METROPOLITAN GOVERNMENT OF NASHVILLE AND DAVIDSON COUNTY

STAFF RECOMMENDATION
1714 Fourth Avenue North
March 18, 2015

Application: New construction—infill and outbuilding
District: Salemtown Neighborhood Conservation Zoning Overlay
Council District: 19
Map and Parcel Number: 08205007600
Applicant: Preston Quirk
Project Lead: Melissa Baldock, melissa.baldock@nashville.gov

Description of Project: Application is to construct new infill and an outbuilding.

FOUNDATION PLAN

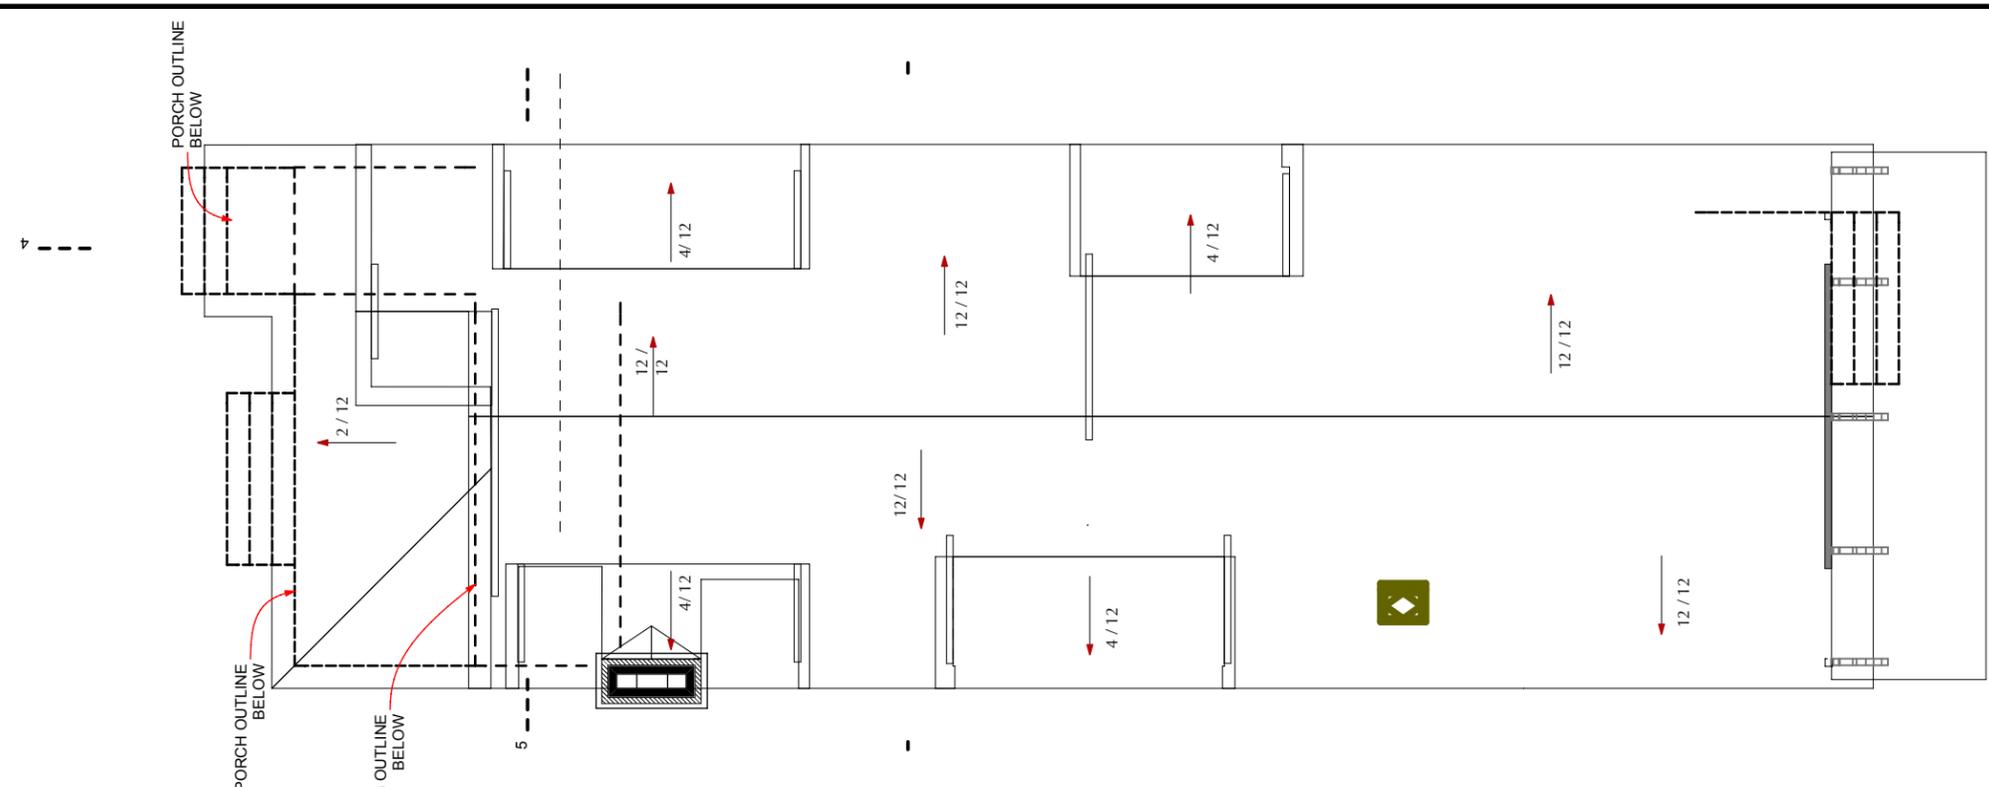
Because the lot is unusually narrow at thirty-two feet, six inches (32'6") wide, the house is also narrow at twenty-two feet, six inches (22'6") wide. Staff finds this width to match surrounding context, where houses range in width from fifteen to thirty-six feet (15'-36'). The house will be seventy-three feet (73') deep. Staff notes that the foundation

plan reflects an earlier design with a rear bump out on the right elevation, and asks for an updated foundation plan.

1. The applicant submit an updated foundation plan;
2. The finished floor height be consistent with the finished floor heights of the adjacent historic houses, to be verified by MHZC staff in the field;
3. Staff approve the final window and door specifications, the metal roof color, the porch floor material, and a brick sample prior to purchase and installation of these materials; and
4. The HVAC shall be located behind the house or on either side, beyond the mid-point of the house.

1 FRONT ELEVATION
SCALE: 1/8" = 1'-0"

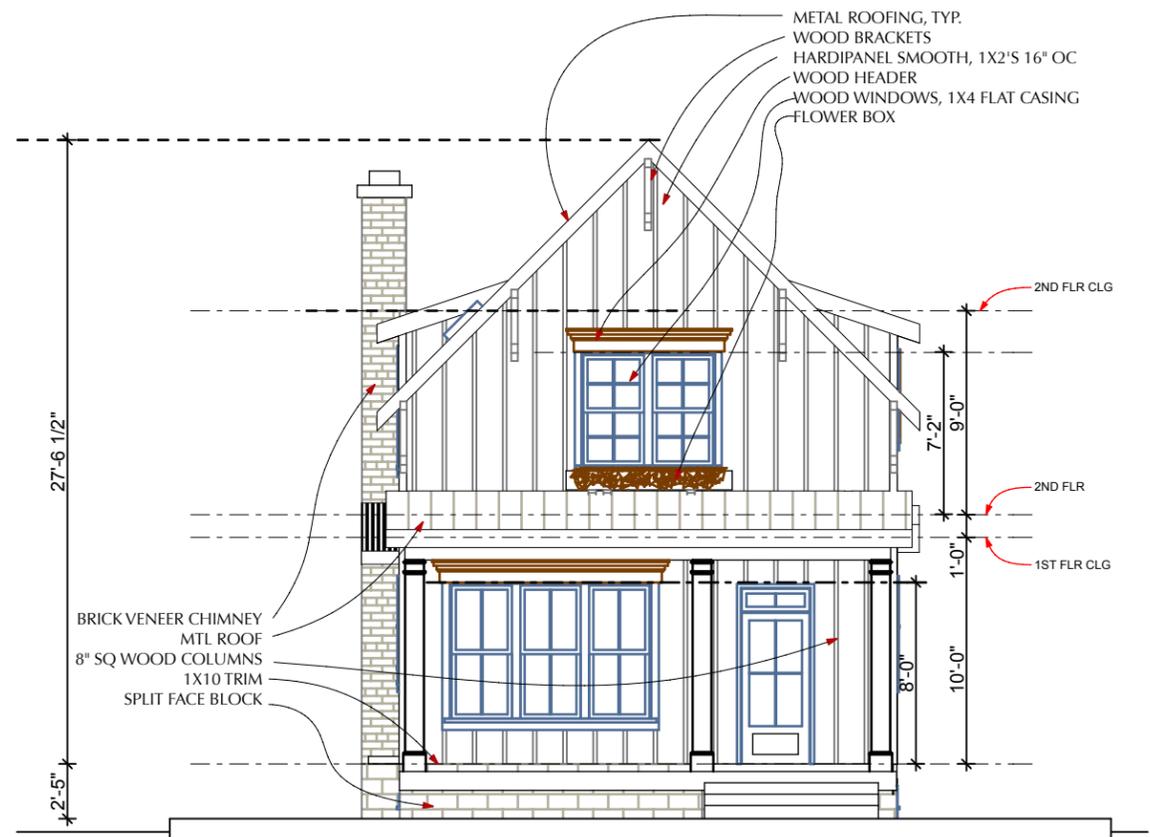
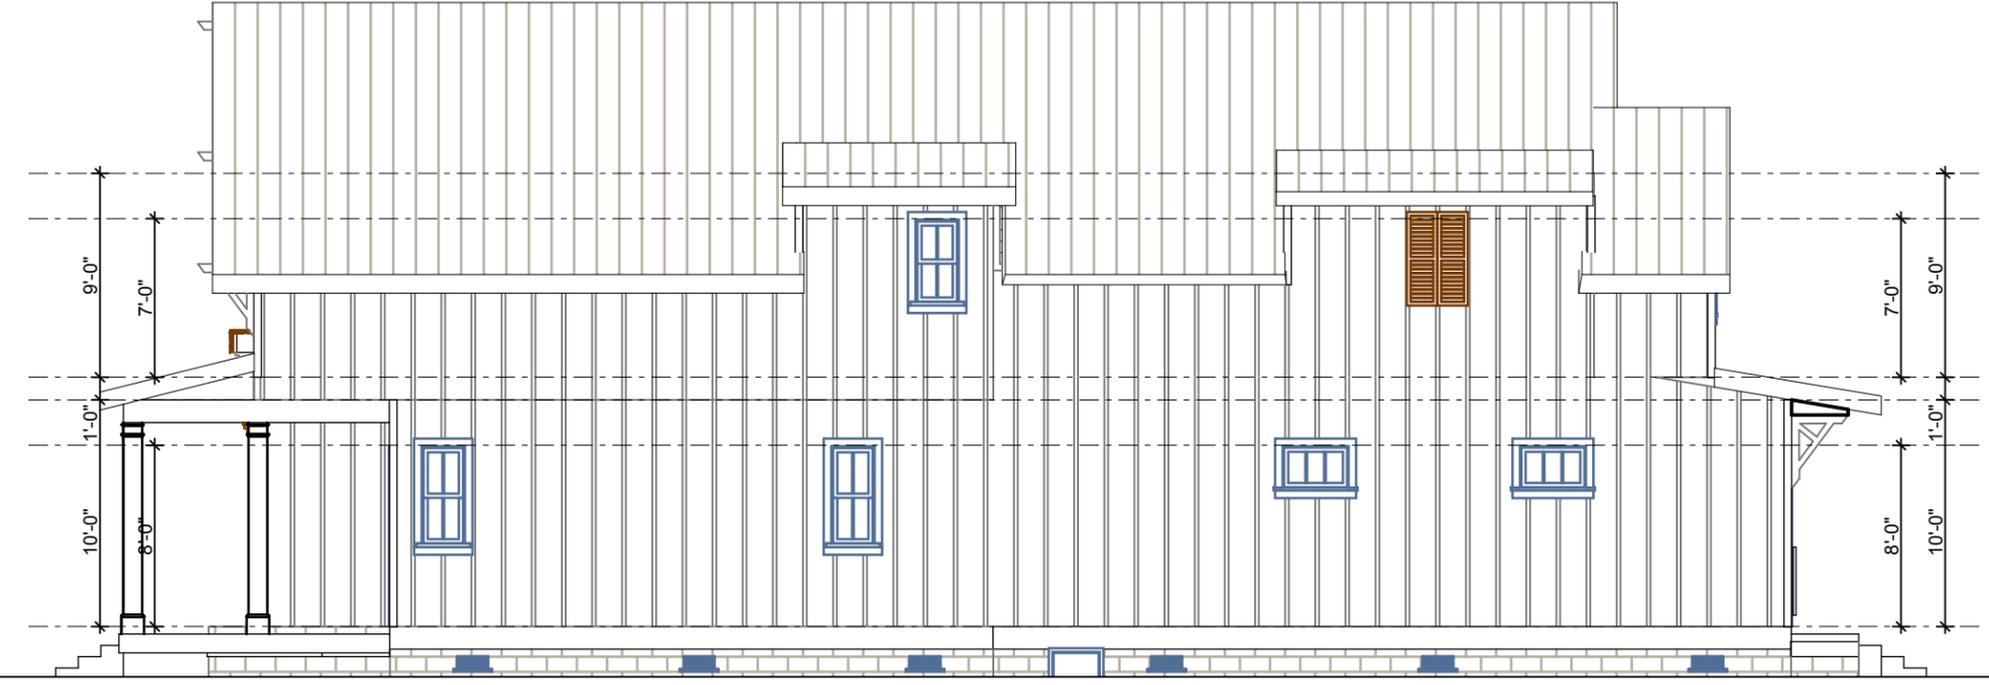
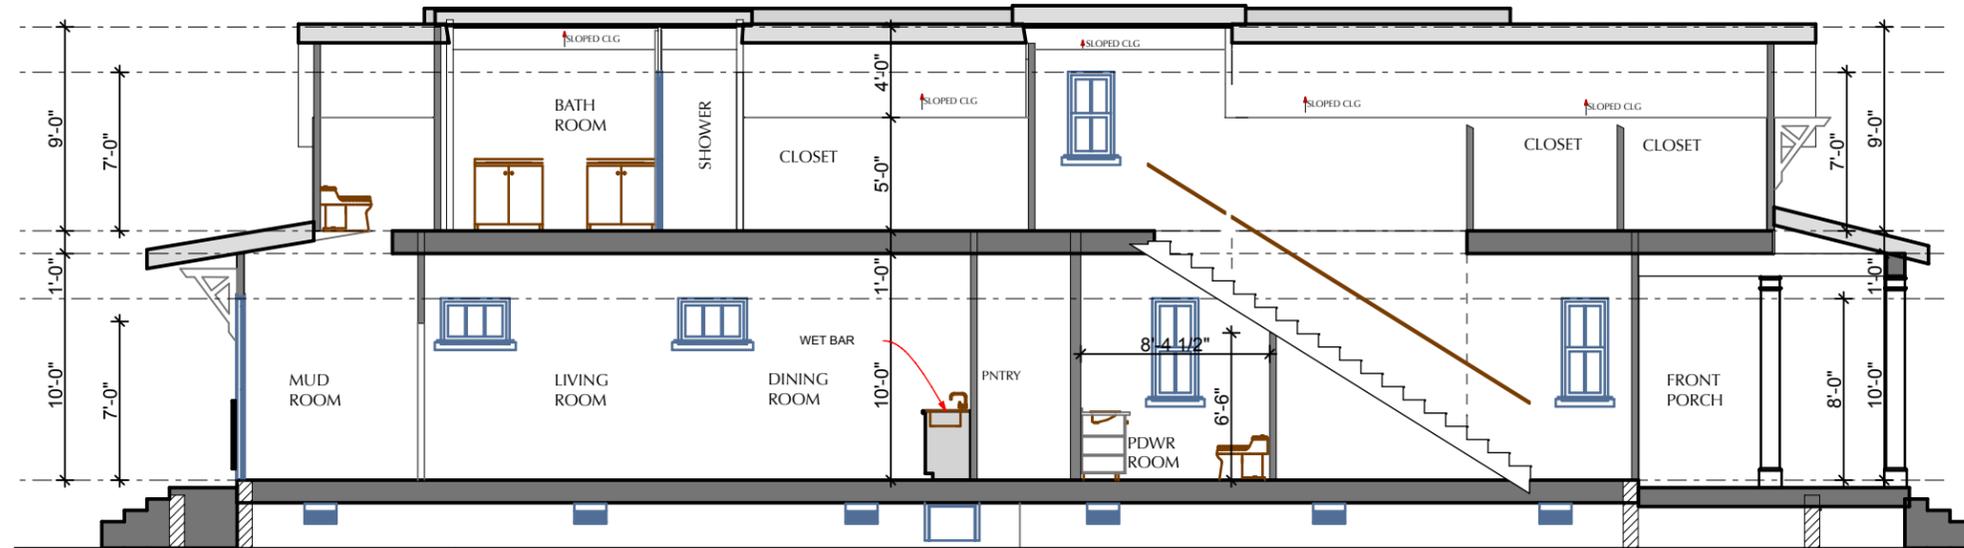
Height & Scale: The proposed infill will be one-and-a-half stories in height. It will have an eave height of approximately seventeen feet (17') above grade, and a ridge height of approximately twenty-eight feet, six inches (28'6") above grade. Staff finds that this height meets the neighborhood context, where structures range in height from seventeen to thirty-four feet (17'-34'). The foundation height is shown as approximately one foot, three inches (1'3") tall, and staff asks to verify in the field that the foundation height is compatible with the foundation heights of neighboring historic structures.

Roof form: The primary roof form is a front facing gable with an 11/12 pitch. The porch roof will be a shed with a 2/12 pitch. There will be shed-roofed wall dormers on each side facades with pitches of 4/12. The Commission does not typically approve wall dormers, as they are not common features on historic houses nearby. However, in this instance, the narrowness of the house makes setting the dormers back two feet (2'), as is typically required, problematic. In addition, the wall dormers are located on the back half of the side facades, reducing their visibility from the street. Staff finds that the infill's roof forms meet Section III.E. of the design guidelines.

Proportion and Rhythm of Openings: The primary windows on the proposed infill are generally twice as tall as they are wide, thereby meeting the historic proportions of openings. There are no large expanses of wall space without a window or door opening. Staff finds that the project's proportion and rhythm of openings meet Section III.G. of the design guidelines.

1 GARAGE - 1ST FLR PLAN
SCALE: 1/8" = 1'-0"

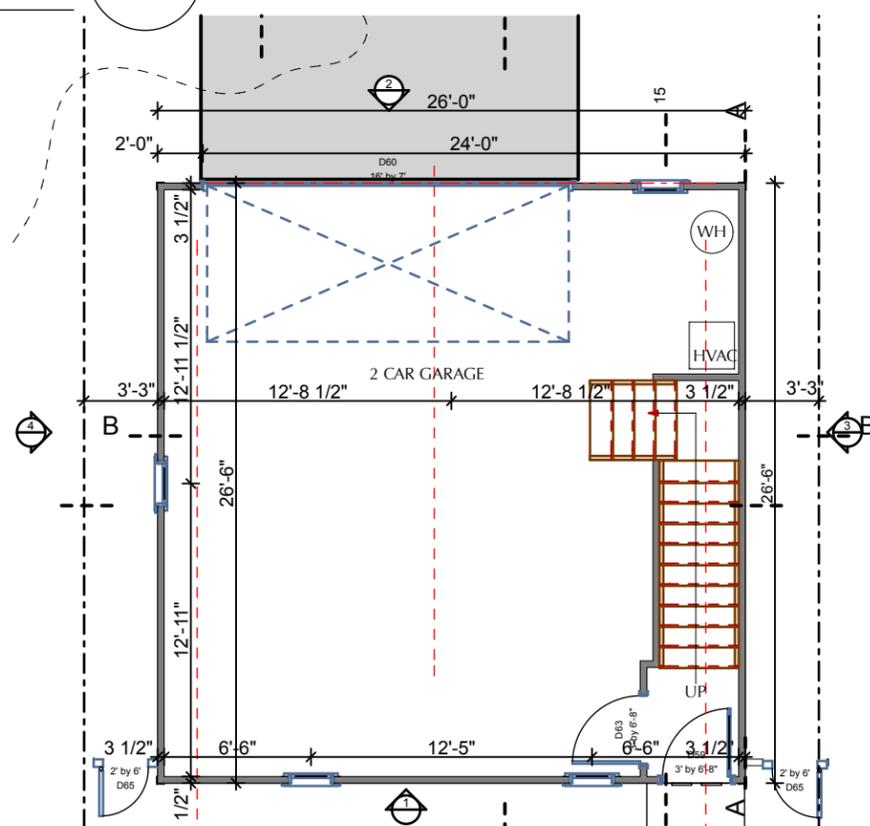
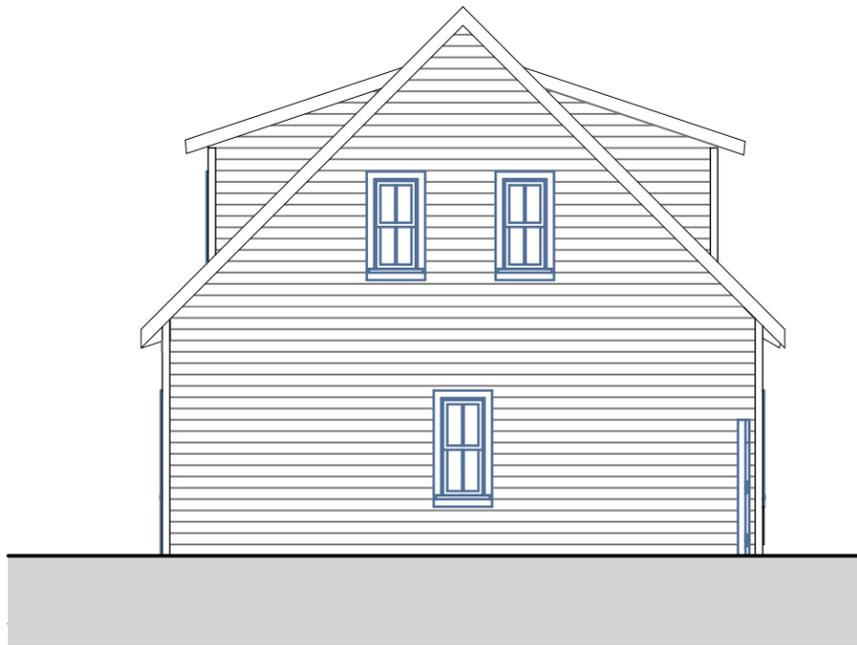
Outbuildings: The proposed outbuilding cannot be used as a detached accessory dwelling unit because the lot size does not comply with Table 17.12.020A of the zoning code. See attached "Outbuilding/DADU Worksheet" for the analysis of the appropriateness of the proposed outbuilding. Staff finds that the outbuilding meets Section III.H. of the design guidelines for an outbuilding without a dwelling unit.

MINIMUM	PROPOSED
Space between principle building and DADU/Garage	20'	37'
Rear setback	3'	20'
L side setback**	3'	3'3"
R side setback**	3'	3'3"
How is the building accessed?	From the alley or existing curb cut	Rear/Alley

Existing conditions (height of historic portion of the home to be measured from finished floor)	Potential maximums (heights to be measured from grade)	Proposed (should be the same or less than the lesser number to the right)
Ridge Height	28'6"	25'	24'3"
Eave Height	17'	1 story 10' or 2 story 17'	10'

Lot is less than 10,000 square feet	Lot is more than 10,000 square feet	50% of first floor area of principle structure	Proposed footprint
Maximum Square Footage	750 sq. ft.	1,000 sq. ft.	732 sq. ft.	688 sq. ft.
